**LEBANON PLANNING BOARD
DECEMBER 9, 2024 - 6:30 PM
COUNCIL CHAMBERS, CITY HALL OR
REMOTE VIA VIRTUAL PLATFORM
LEBANONNH.GOV/LIVE**

Staff Memorandum – PB2024-22-SPRCUP – *con't from 11/12/24*

Site Plan Review and CUP for a proposed 474-unit multi-family PURD, and a CUP to allow an increase in the maximum permitted building height from 45 ft. to 55 ft.

- ▶ Plan set titled “The Brickyard Residential Development,” dated May 10, 2024, latest issue December 4, 2024, prepared by VHB, EV Project: 52933.00 (53 sheets plus cover sheet)

Note

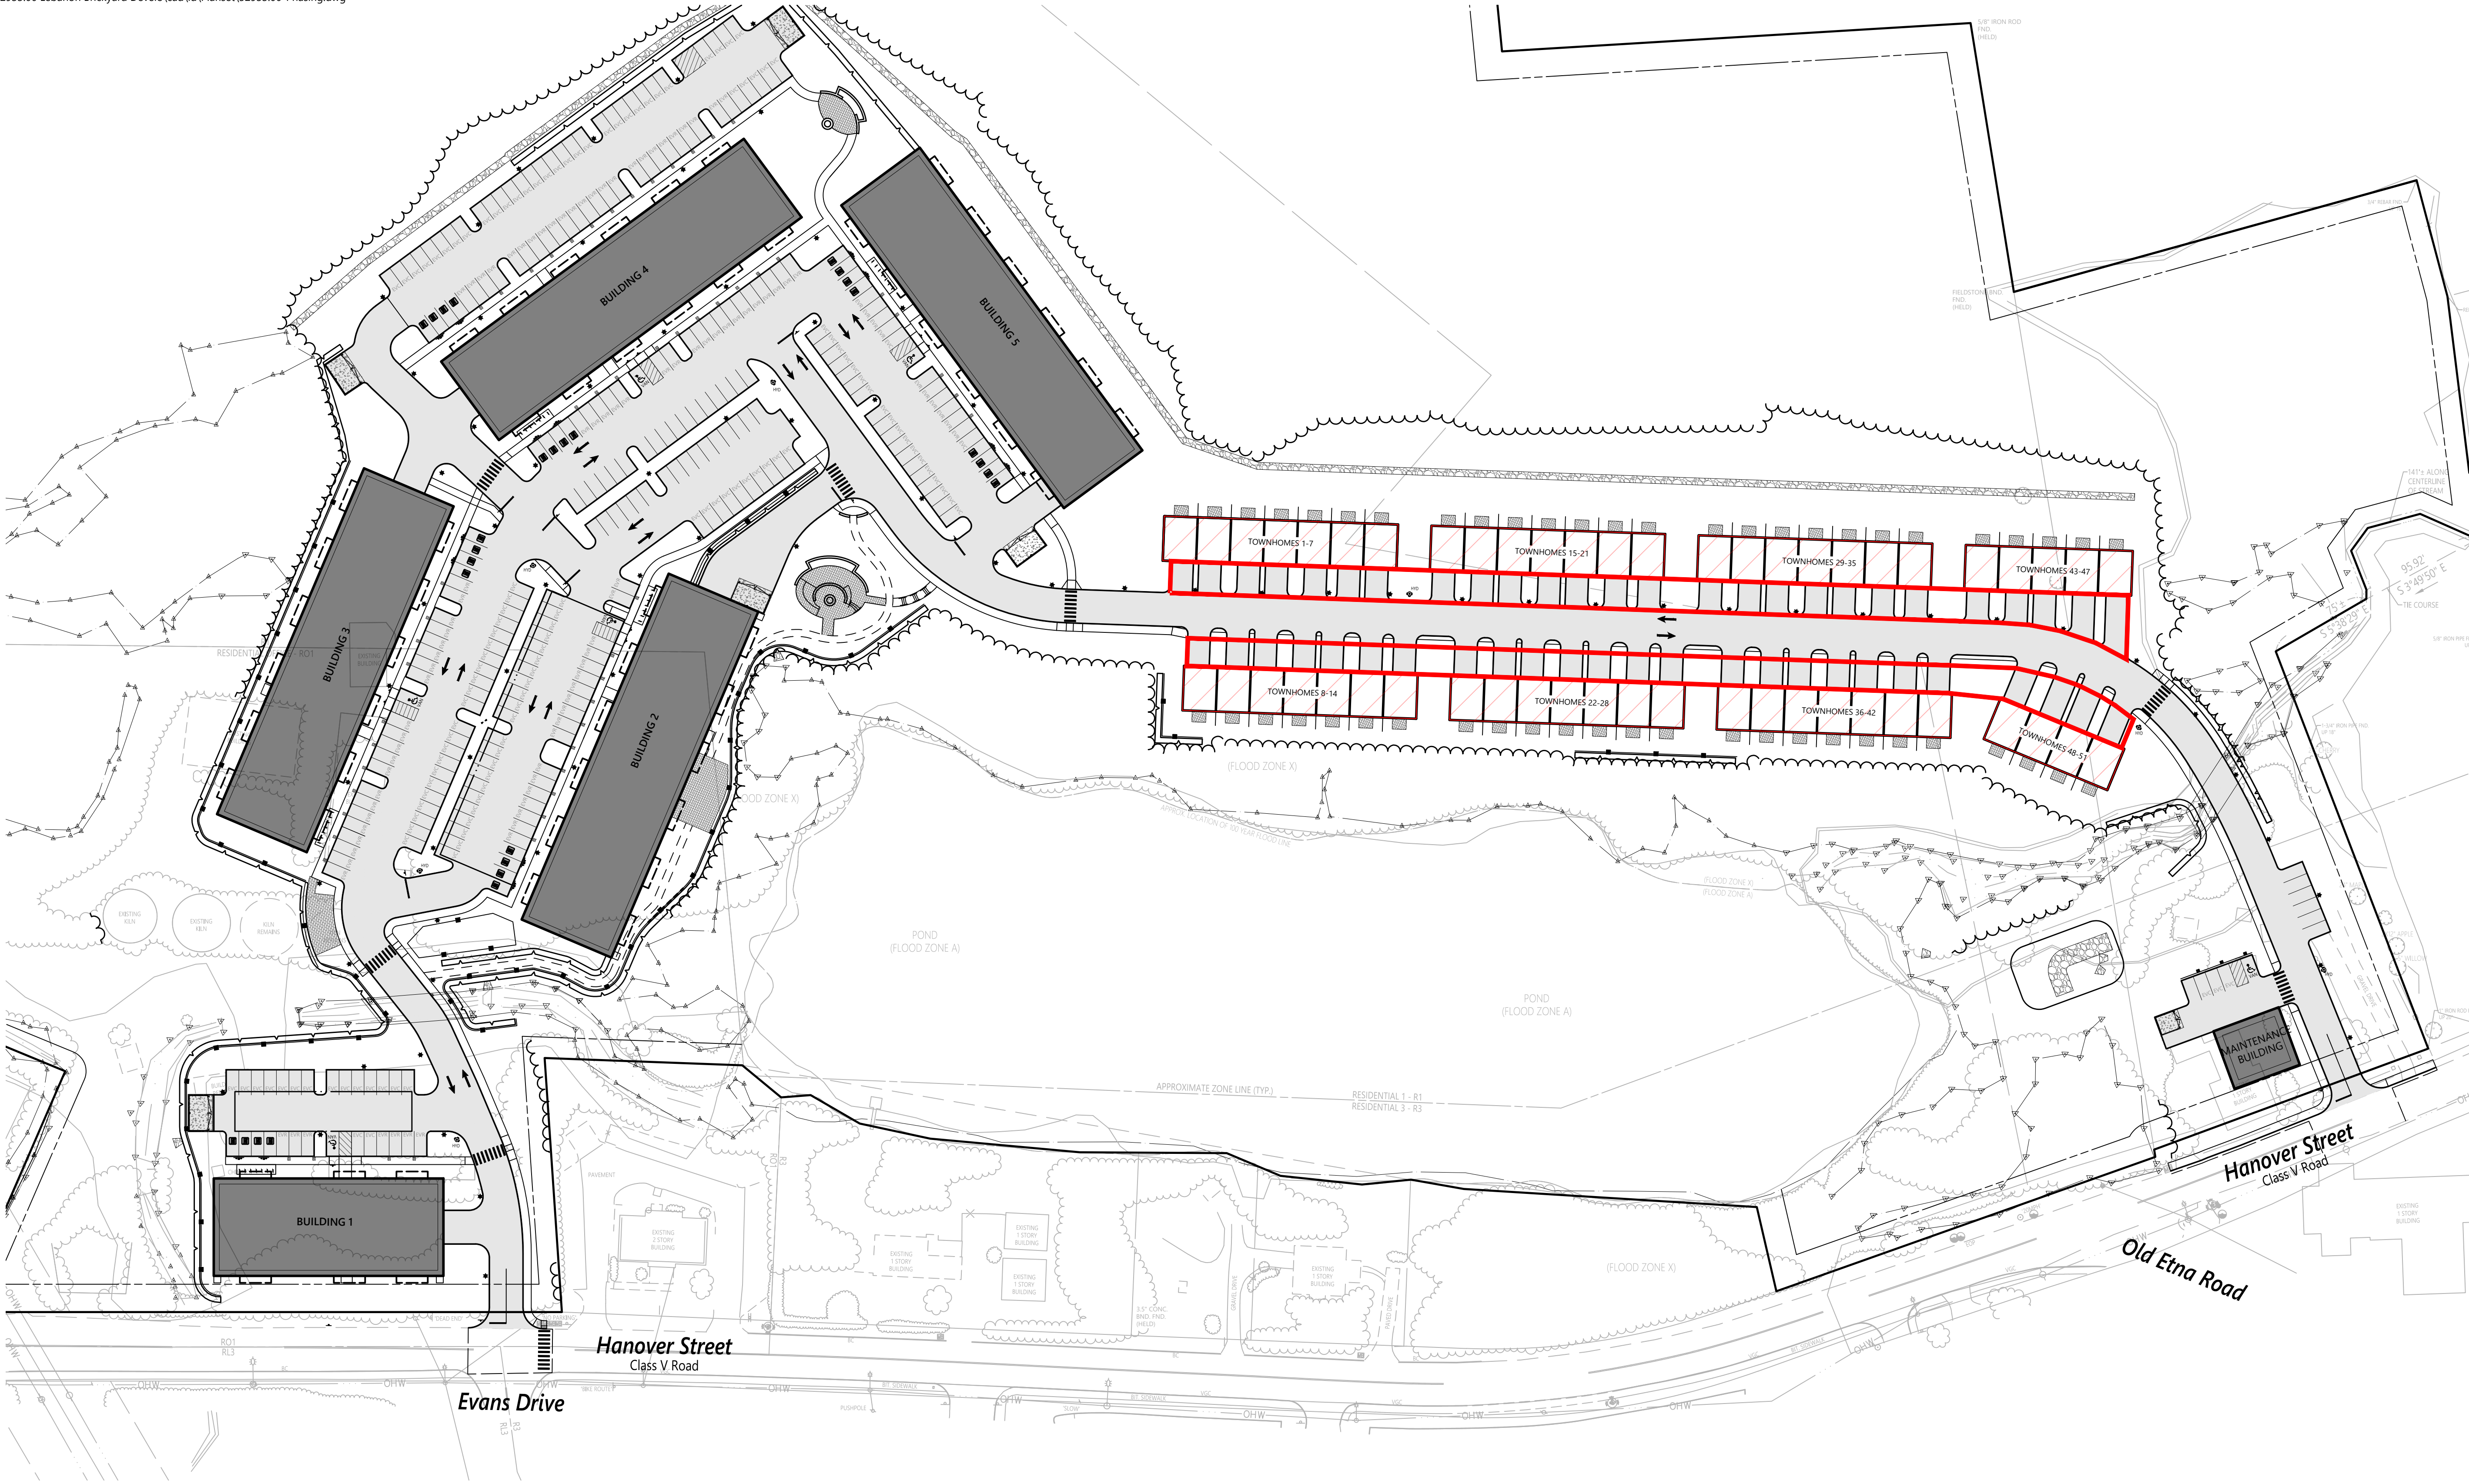
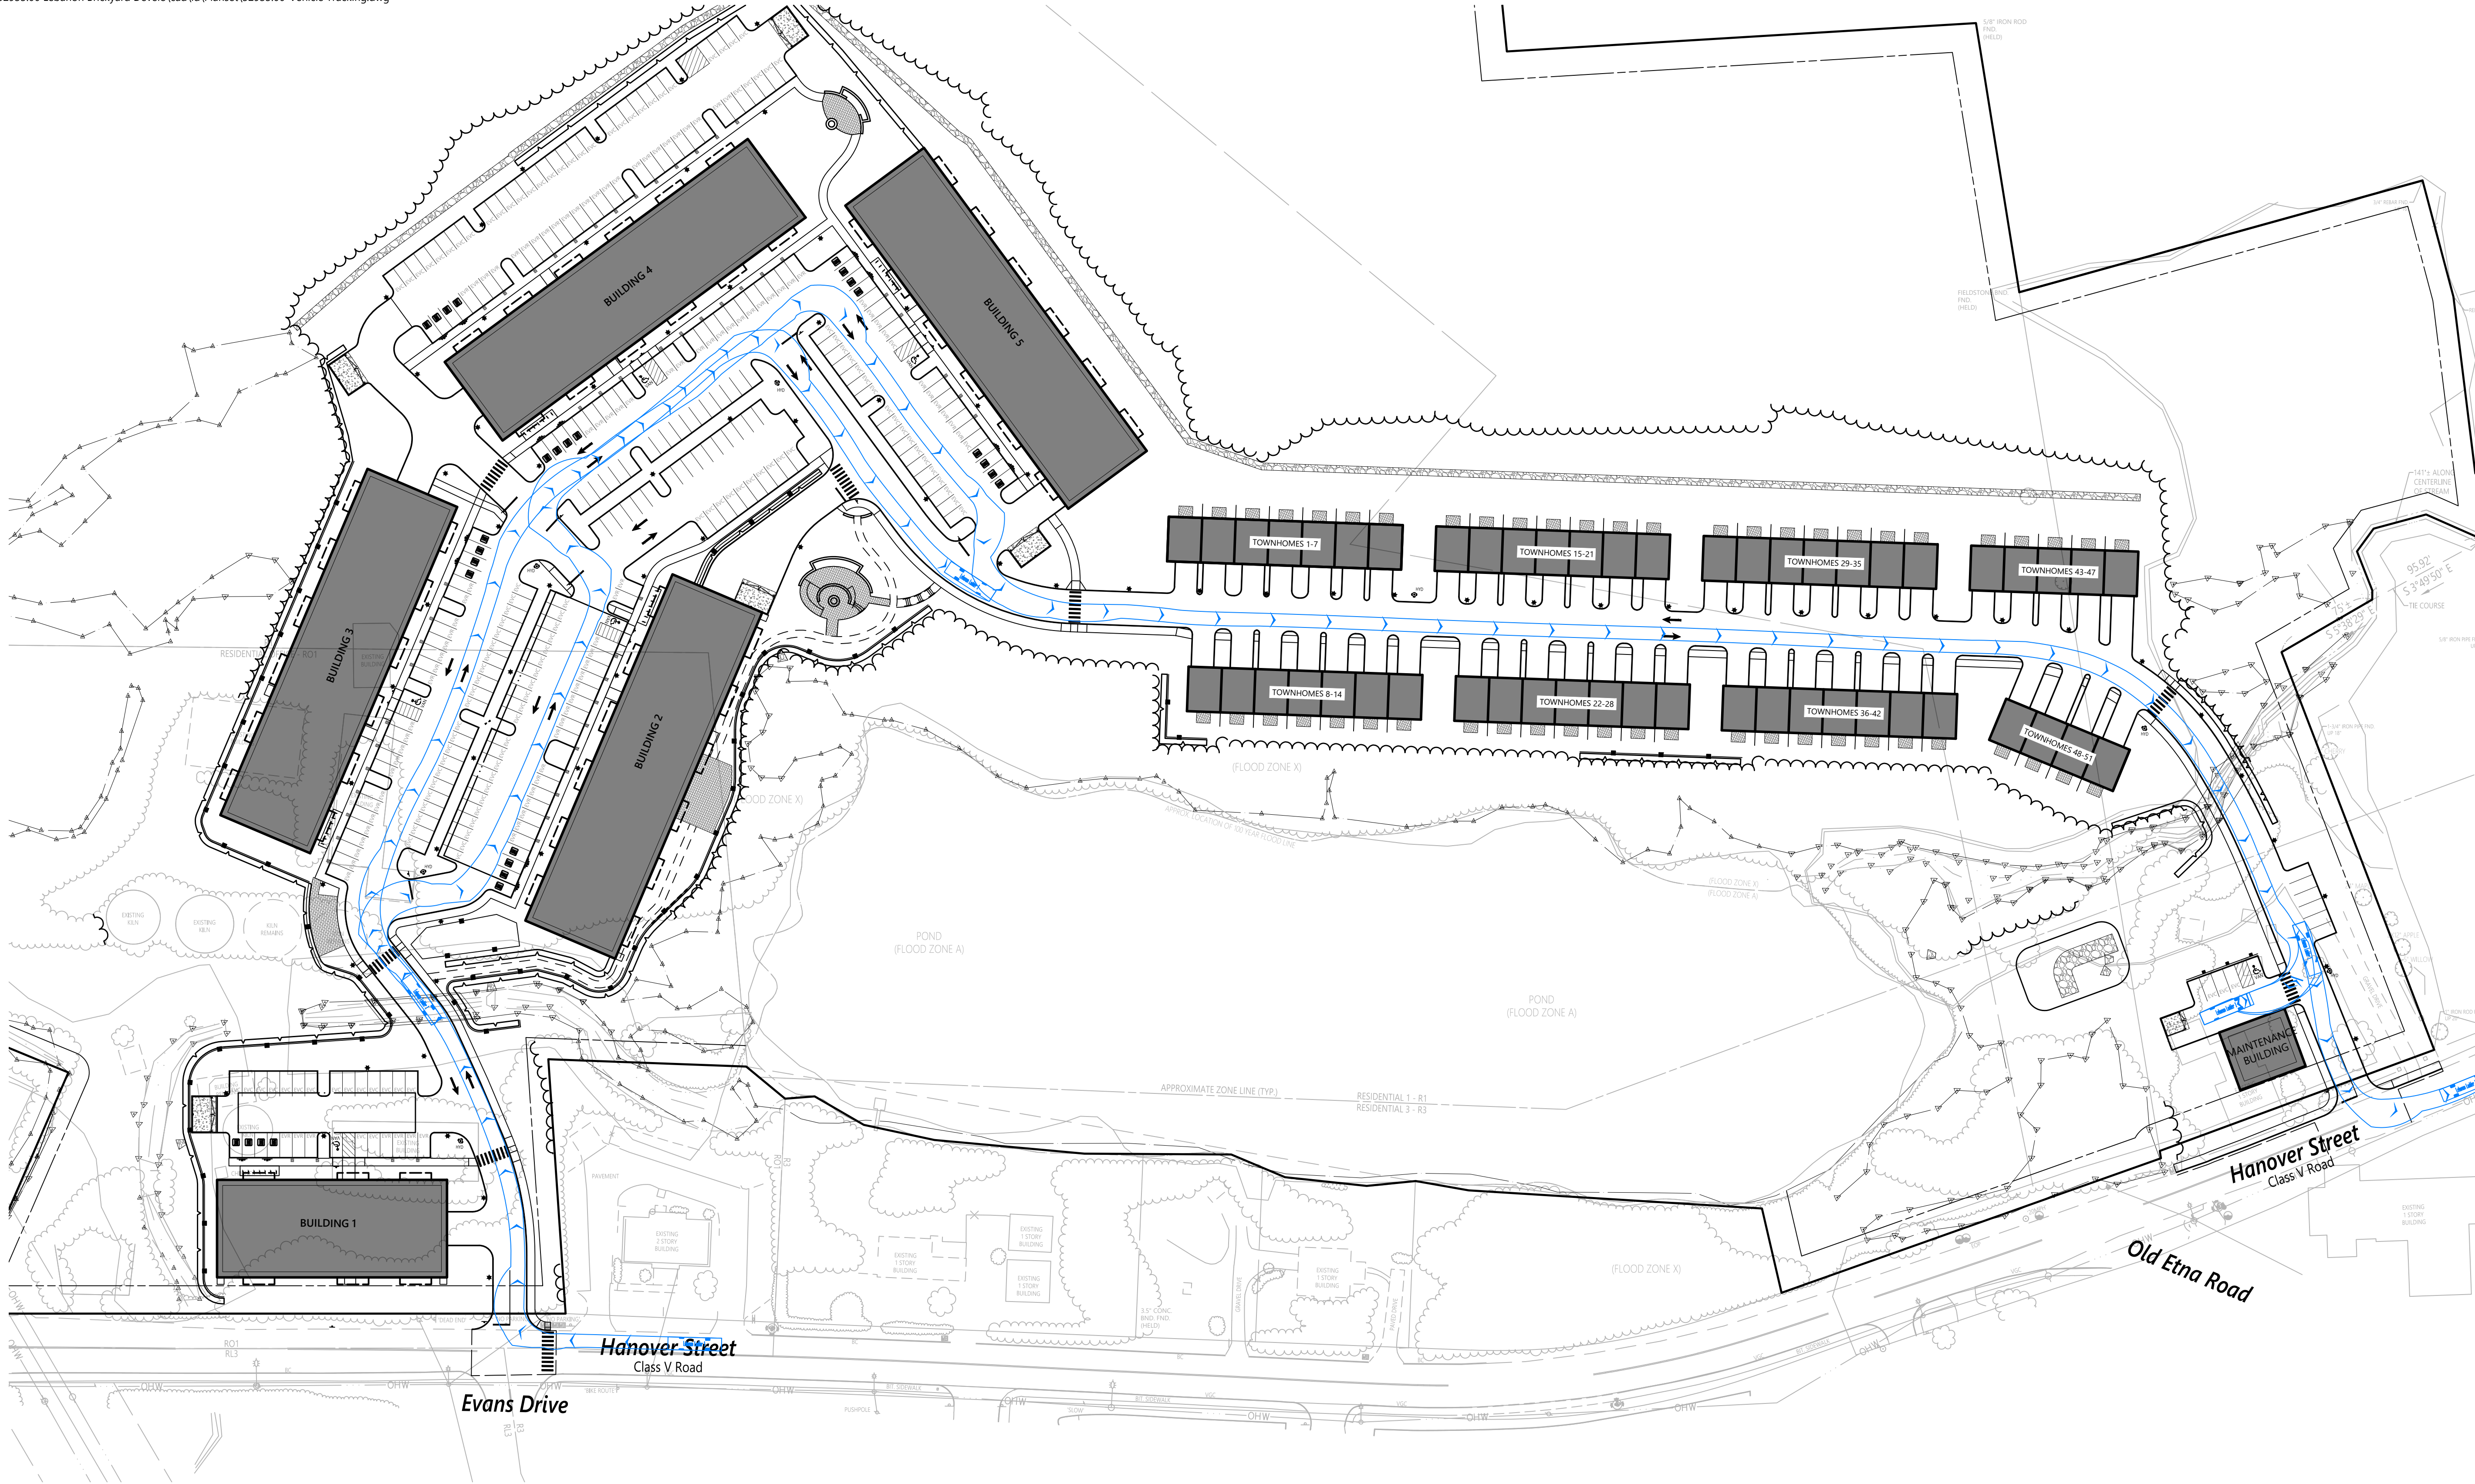
19. Phasing Plan - Sheets 30-33 (C8.1-4)

21
22 Mr. Ford Burley said he noted that (per C8.1 of the Phasing Plan) the townhouses will be built
23 after Phase II, but Buildings B, C, and D will be built based on occupancy and market. He asked if
24 the applicant could provide a commitment to build those townhouses regardless of the market for
25 studio apartments and one-bedroom units. He asked if they have explored whether the townhouses
26 could be made into condominiums. Mr. Fenstermacher said they did look at it, but he thought they
27 would have to have subdivision approval to do that. Mr. Corwin said there may be another way
28 and Mr. Fenstermacher said they will continue to work with Staff to try to accomplish it.

Vehicle Tracking
City of Lebanon Firetruck

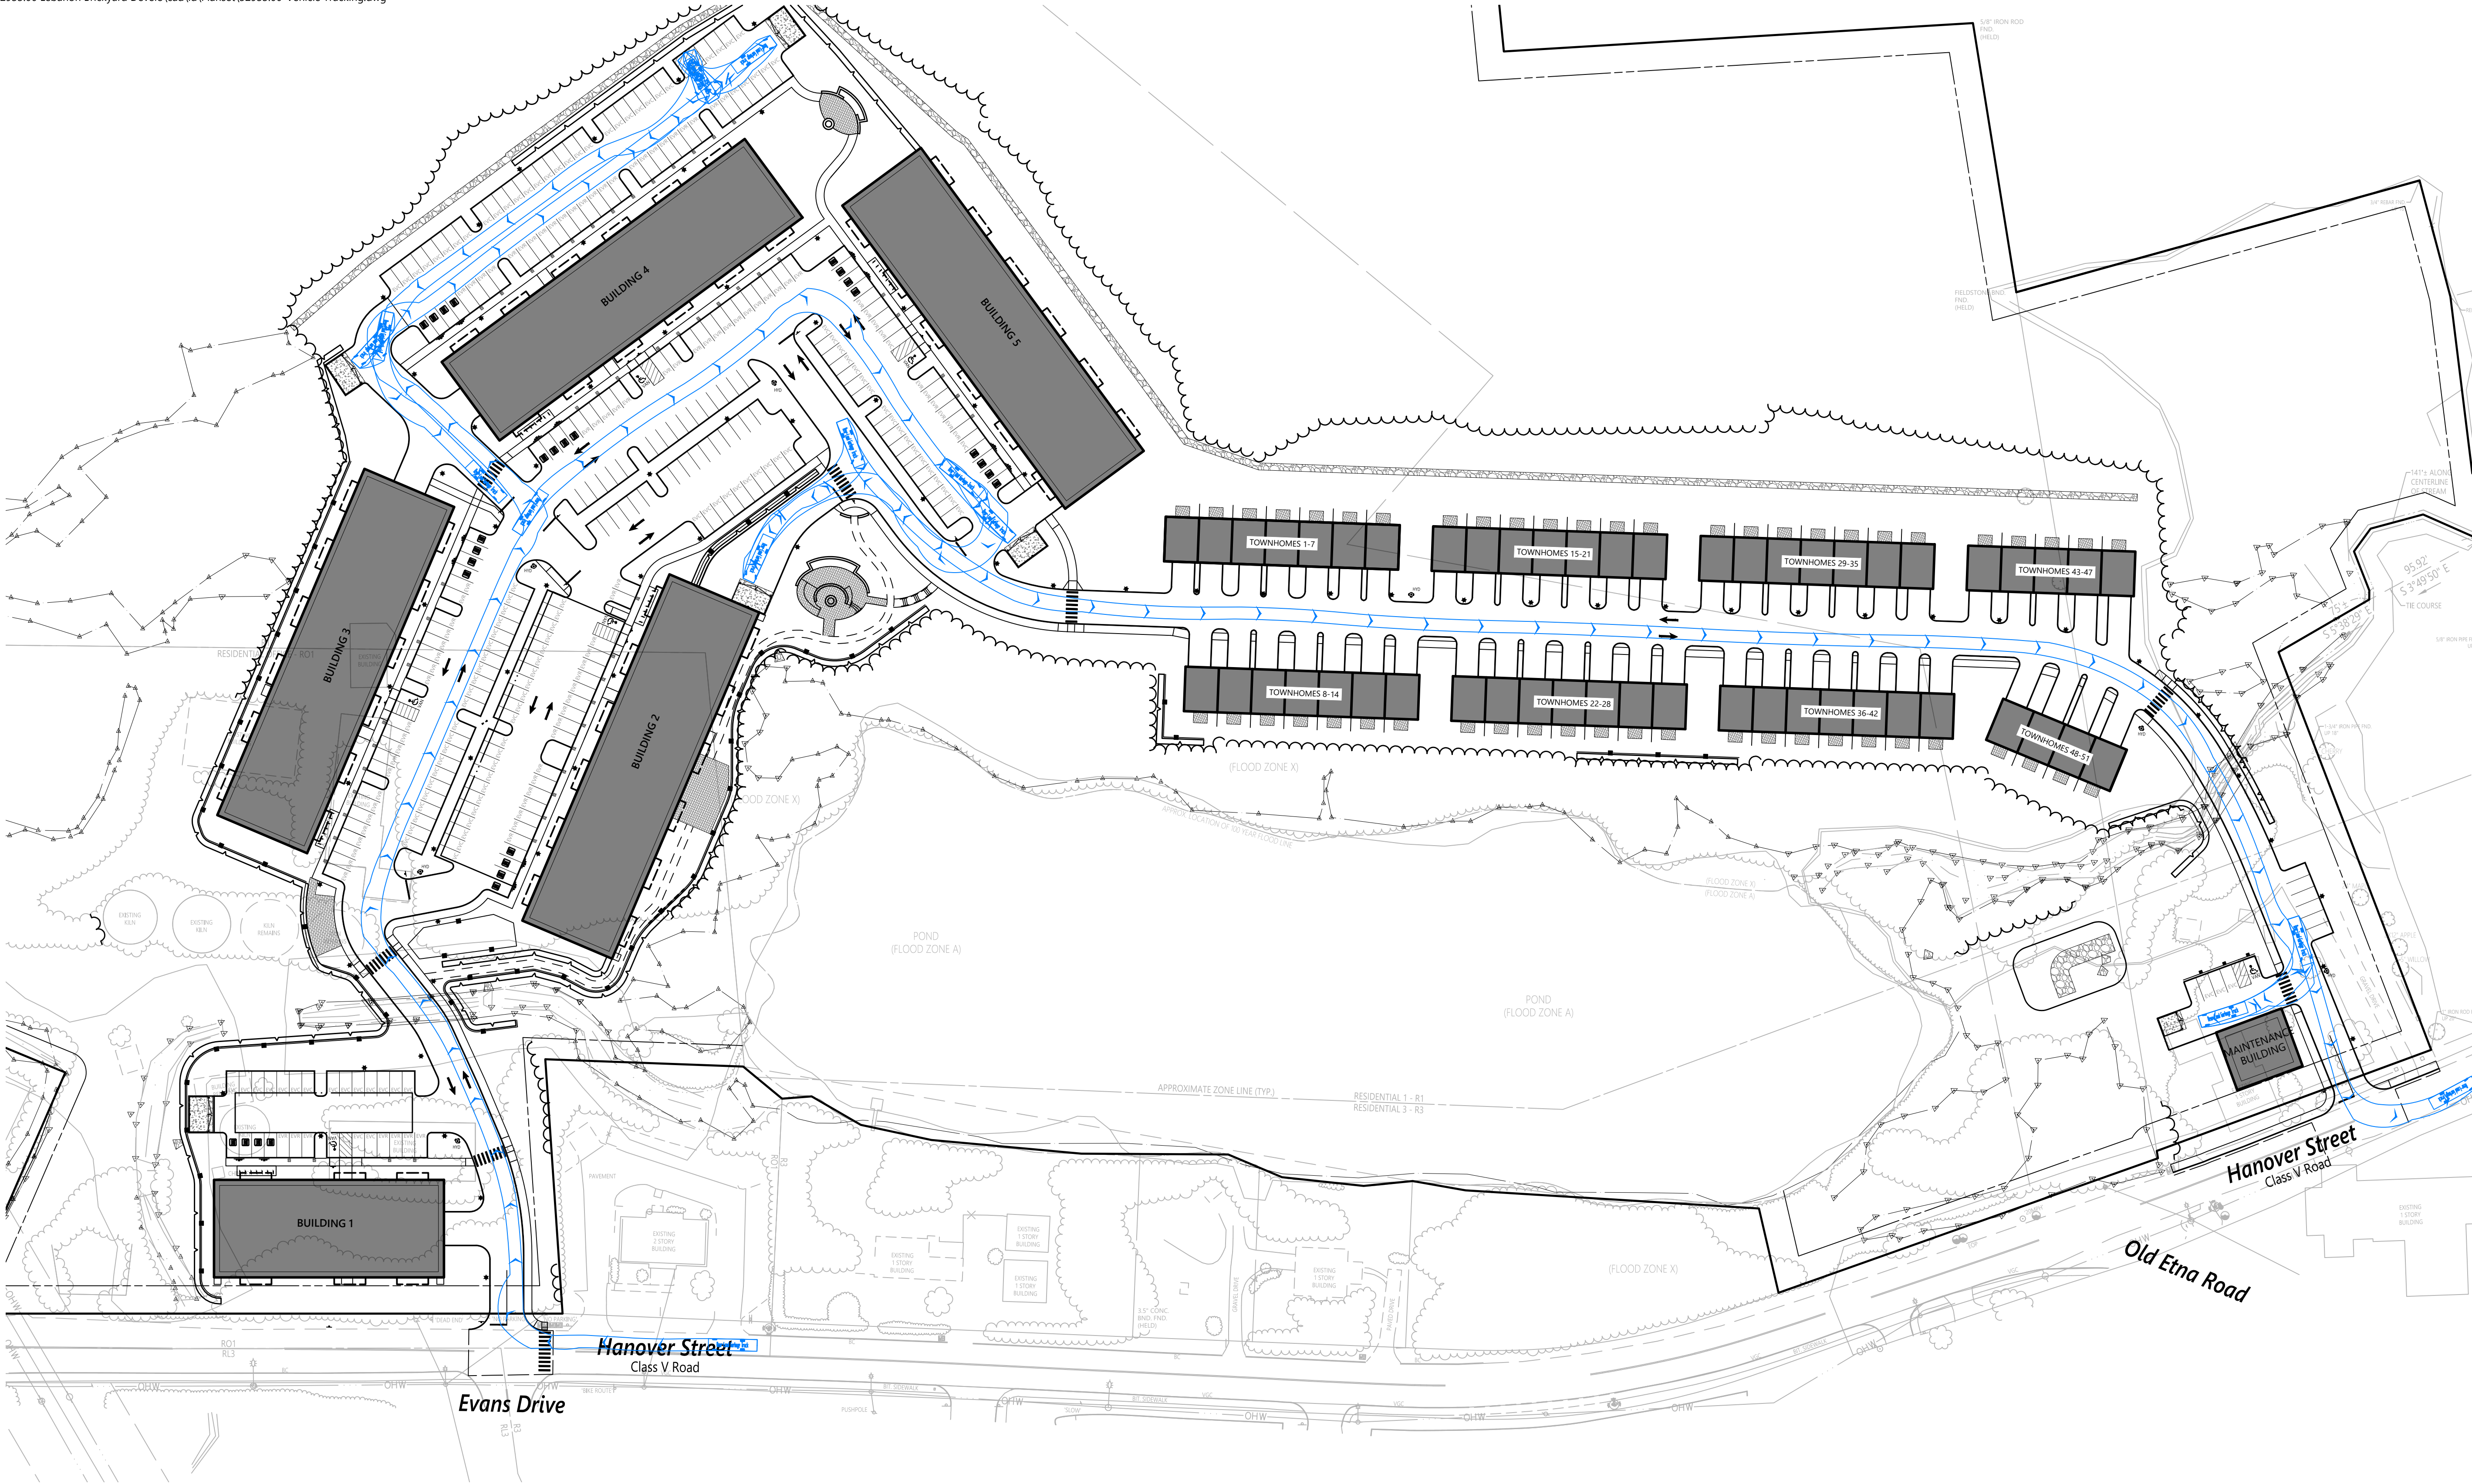
-
- 11. Sheet 36 – why does the development need to be designed to accommodate a semi-trailer?
- 12. Building 2 is located partially in the R-O District and therefore is restricted to a 45 ft. maximum height, whereas the plan set throughout indicates that Building 2 will be 55 ft. Please update
